UNITED STATES PATENT AND TRADEMARK OFFICE

10/597,103

Office Action Summary	Application No. 10/597,103	Applicant(s) KREILING ET AL.	
	Examiner MELISSA A. BLACK	Art Unit 3612

DETAILED ACTION

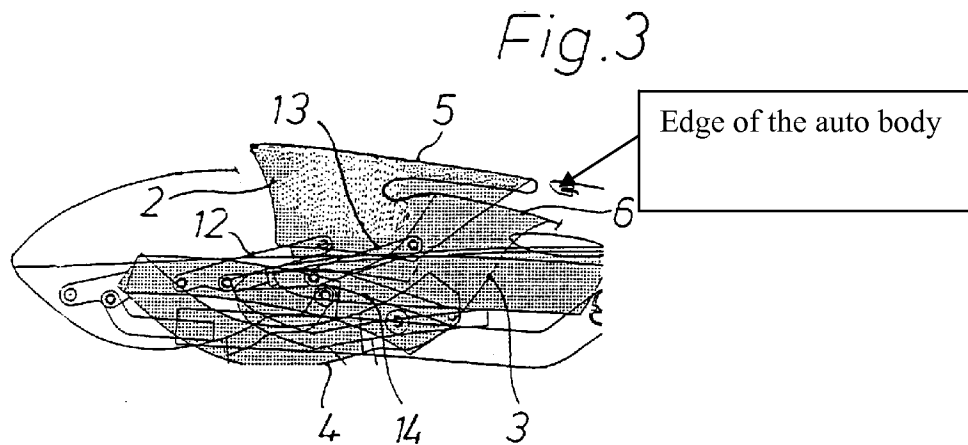
Re Claim 1, Corder et al discloses a cabriolet vehicle (Figure 1) with a roof (10) provided with a flexible cover (20) in at least parts of its area, which includes a front roof area (22), which can be stored in the same orientation as in the closed state in a body recess, which is bounded on the rear by an edge of the auto body, characterized by the fact that the outer surface of the front roof area (22) is separated relative to the rear roof area (24) lying farther rearward and provided with cover (20) and that the rear edge of the front roof area (22) is adapted to the trend of the edge of body bounding the body recess on the rear. Re Claim 2, Corder et al discloses a separation joint between the front roof area (22) and the adjacent rear roof area (24) opens during roof storage, and that the additional roof area (24) adjacent behind the rear edge of the front roof area (22) can then be displaced beneath the front roof area (22, See Figures 3 and 4). Re Claim 3, Corder et al discloses the front roof area (22) in the stored state of roof (10) lies at approximately the same height with said edge that is adjacent behind and an additional auto body outside surface adjacent to it (See Figure 7). Re Claim 4, the remaining gap between the rear edge of the front roof area (22) and the auto body edge bordering the recess is narrower than 40 millimeters (See Figure 7). Re Claim 5 as best understood by the examiner, Corder et al

Re Claim 1, Busch discloses a cabriolet vehicle with a roof (Figure 1) provided with a flexible cover (1) in at least parts of its area, which includes a front roof area (5), which can be stored in the same orientation as in the closed state in a body recess (Figure 3), which is bounded on the rear by an edge of the auto body (See Figure 3), characterized by the fact that the outer surface of the front roof area (5) is separated relative to the rear roof area (6) lying farther rearward and provided with cover (1) and that the rear edge of the front roof area (5) is adapted to the trend of the edge of body bounding the body recess on the rear (See figure below).
